1818 6TH AVE

601 Stewart St, 1818 6th Ave, 600 Olive Way
Project #: 3038765-LU

DRB RECOMMENDATION MEETING

DOWNTOWN DESIGN REVIEW BOARD
December 13, 2022

DEPARTURE REQUEST 3.C: OVERHEAD WEATHER PROTECTION

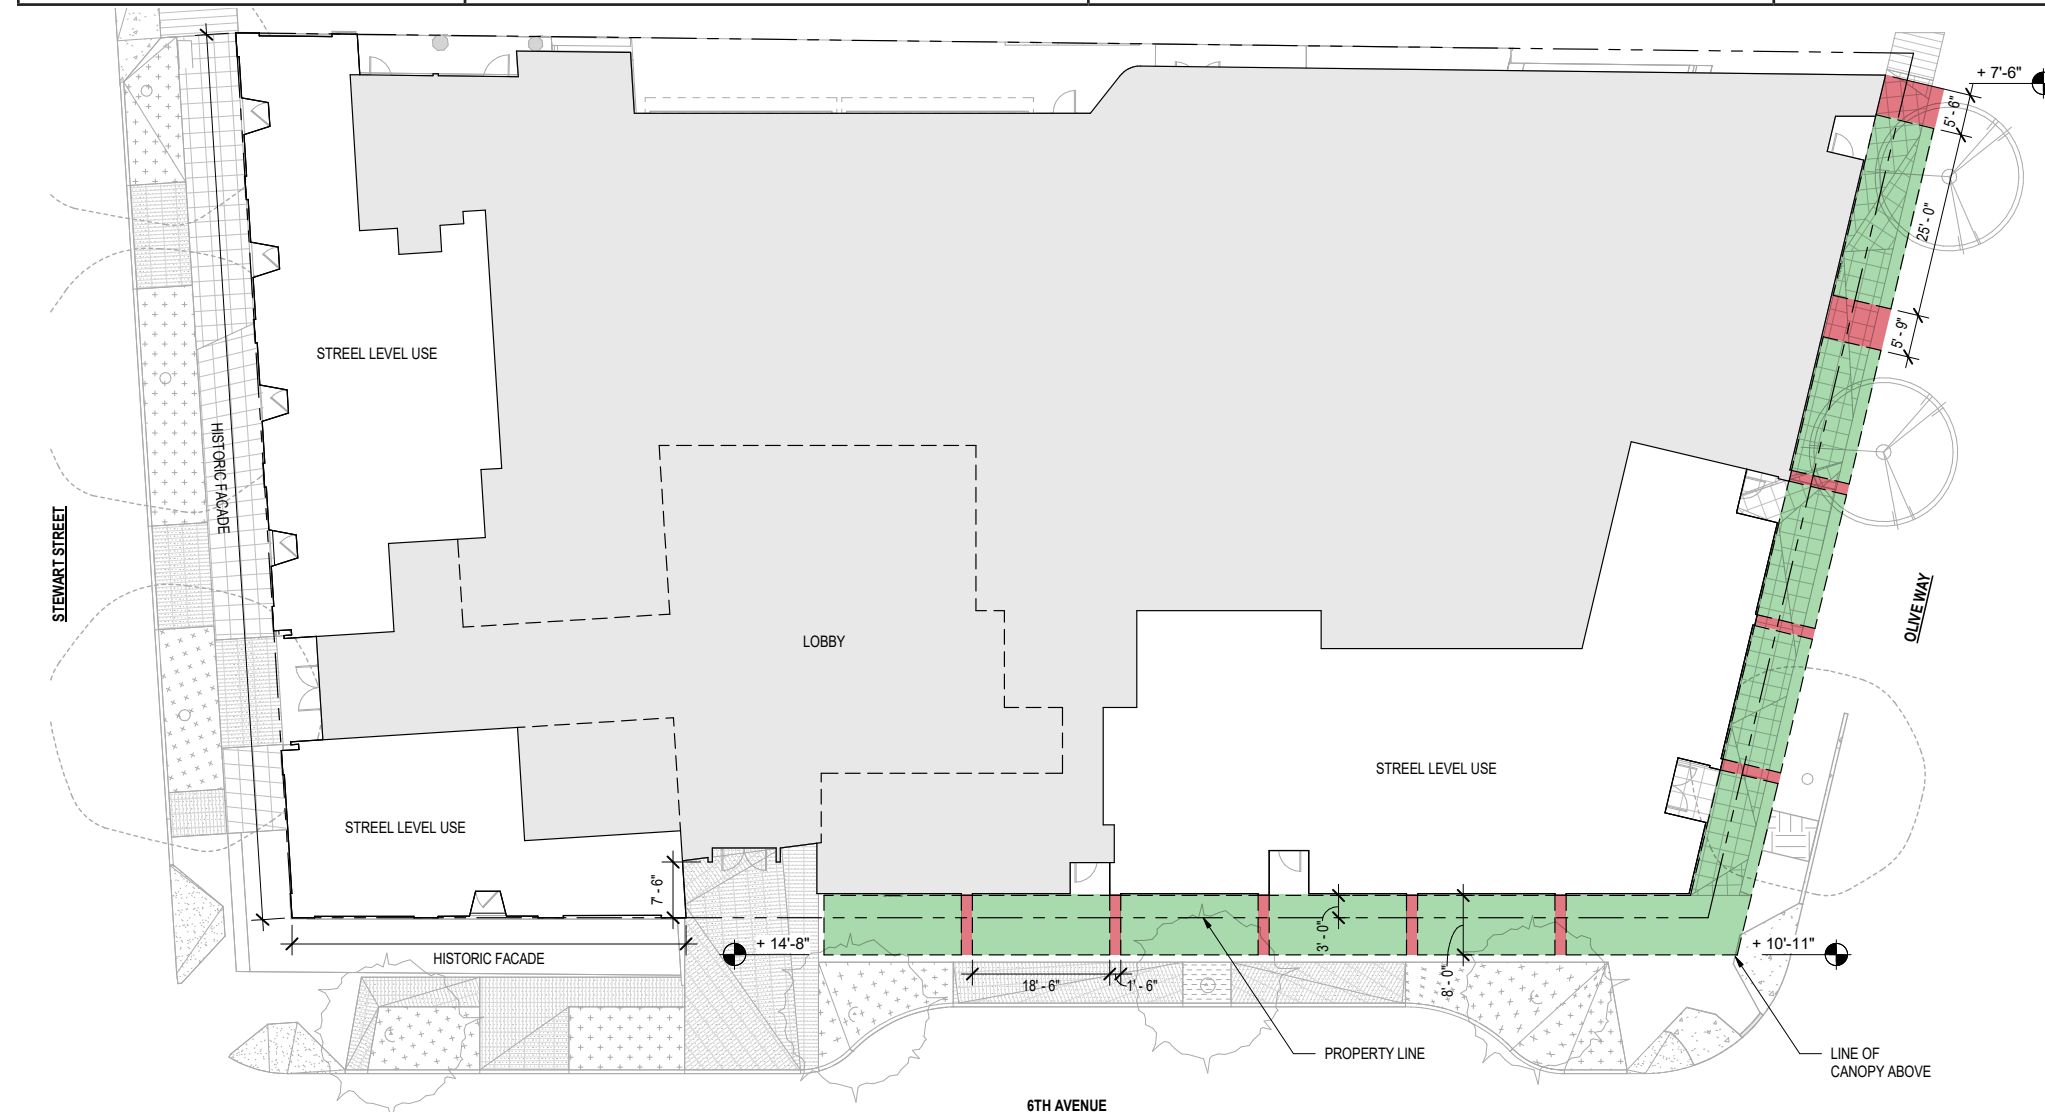
CODE CITATION	REQUIREMENT	DEPARTURE	RATIONALE	DESIGN GUIDELINES
23.49.018 Overhead Weather Protection	23.49.018.A: Continuous overhead weather protection shall be required for new development along the entire street frontage of a lot	1'-6" gaps at pier locations and canopy gaps on either side of the raised canopy at the eastern end of Olive Way	Facade piers at grade have been introduced to continue the rhythm and human scale of the historic Lloyd Building. The design team proposes a departure to allow 1'-6" canopy gaps at pier locations to reinforce this relationship. The rising sidewalk condition along Olive Way makes it impossible to keep a consistent canopy datum. The eastern most portion of canopy is raised to 10'-2" above grade, and the design team proposes a departure to allow canopy gaps on either side to facilitate this height transition.	B-3 Reinforce the positive urban form & architectural attributes of the immediate area.
